LANDSCAPE PLAN - ACCURITE INC.

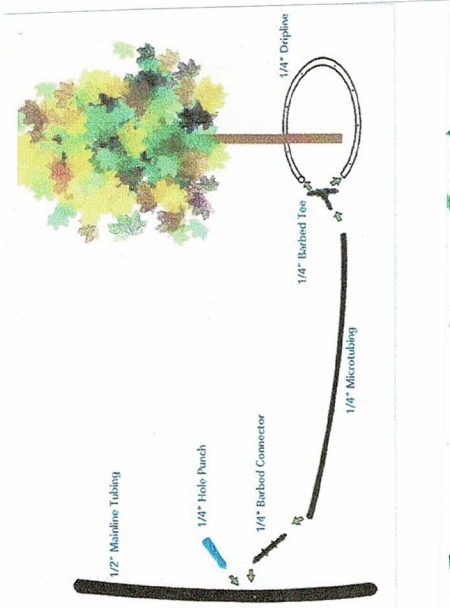
Can we please see some plantings within the ground cover areas?

Please include irrigation plan for additional plantings

Improvements are required to be installed or escrowed for prior to design review approval.
